Product Safety Recall

16107 Accelerator Pedal Entrapment

Reference Number: N15201881

Revision Description: The service procedure in this bulletin has been revised. Please discard all copies of 16107.

4628745

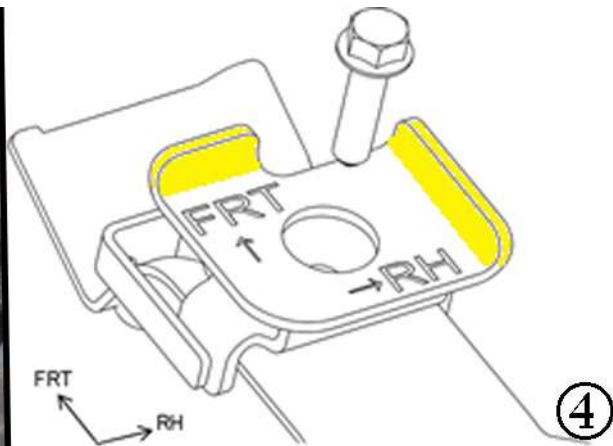
3. Remove the stopper bolt (1) and nut, using 12mm wrench. Discard both the old stopper bolt and nut.

4620177

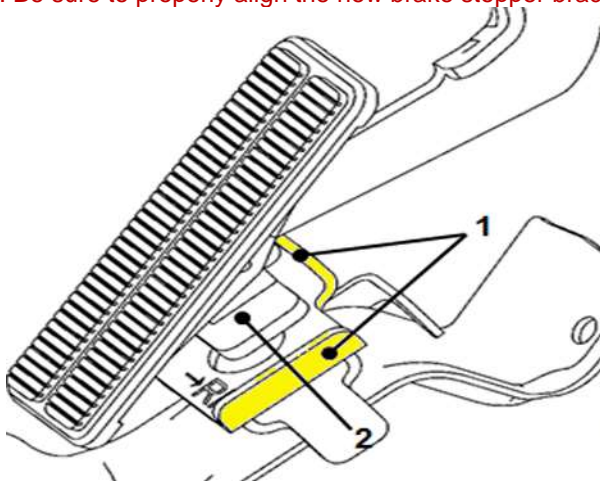
4. Temporarily install the new stopper bracket and new stopper bracket mounting bolt (3). When tightened (even by hand), the head of the new mounting bolt should be below the flat surface of the new stopper bracket.

Note: Be sure to properly align the new brake stopper bracket as indicated (4).

4620179

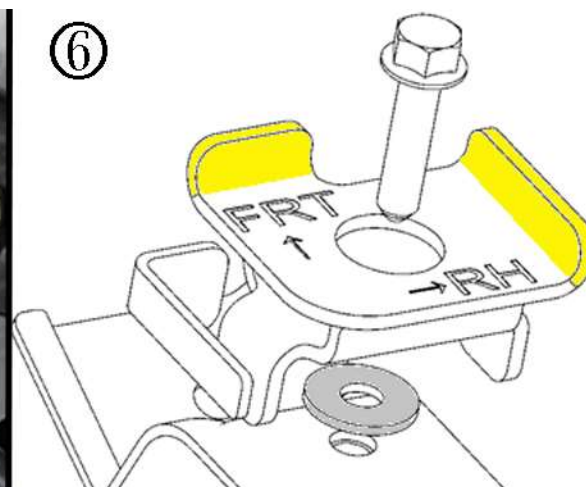
5. Depress the accelerator and ensure the stopper plate (2) does not hit the flanged area of the stopper bracket (1).
